Access Compliance Report

Public Rights-of-Way

(Curb Ramps)

Intersection ID: 46500	Main Street: NEWBRIDGE_RD	Cross Street: ROCK_ISLAND_RD	Location: NE
ADA ID: DDD0EFD67B93	Ramp Type: PerpDiag	Initial Pass/Fail: Fail	Overall Compliance: No
Severity Score: 22.5			
Codes/Mitigation Info/Possible Solution		Field Measurements/Component Compliance

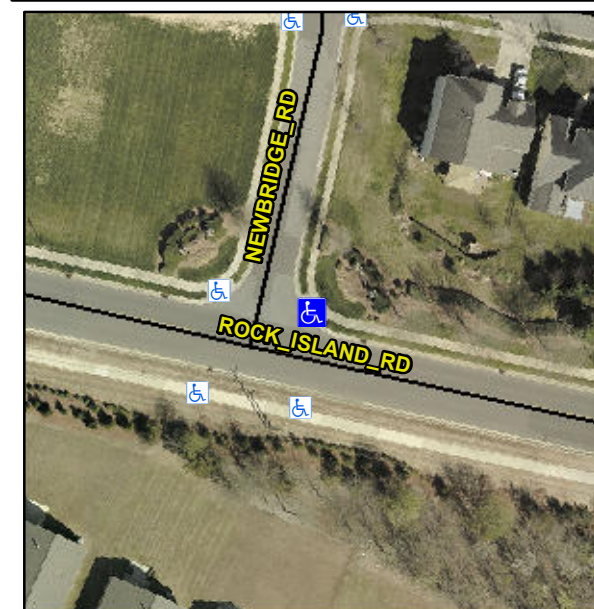
Not Found, R304.5.1, R304.2.2, R304.5.3

Compliance	Description	Data	Compliance	Description	Data
N/A	Ramp Length (in)	47.0	No	Ramp Slope (%)	9.2
No	Ramp Width (in)	46.0	No	Ramp XSlope (%)	4.3
N/A	Flare Type LT	N/A	N/A	Flare Type RT	N/A
N/A	Flare Slope LT (%)	N/A	N/A	Flare Slope RT (%)	N/A
N/A	Flare Traversable LT?	N/A	N/A	Flare Traversable RT?	N/A
N/A	Landing Length (in)	N/A	N/A	DWS Provided?	N/A
N/A	Landing Width (in)	N/A	N/A	DWS Contrast?	N/A
N/A	Landing Slope (%)	N/A	N/A	DWS Length (in)	N/A
N/A	Landing X Slope (%)	N/A	N/A	DWS Full Width?	N/A
N/A	Landing Curb? (Y/N)	N/A	N/A	DWS Offset (in)	N/A
N/A	Shared Landing?	N/A			
N/A	Gutter Ponding?	N/A	N/A	Gutter Slope (%)	N/A
N/A	Gutter Lip Ht (in)	N/A	N/A	Gutter X Slope (%)	N/A
N/A	Painted X Walk1?	No	N/A	Painted X Walk2?	No
	X Walk 1 Direction	To NW		X Walk 2 Direction	To SW
N/A	X Walk 1 Width (in)	N/A	N/A	X Walk 2 Width (in)	N/A
	X Walk 1 Slope (%)	0.9		X Walk 2 Slope (%)	0.2
	X Walk 1 X Slope (%)	2.3		X Walk 2 X Slope (%)	2.0

Remove & Replace Curb Ramp With Two New Directional Ramps or Equivalent.
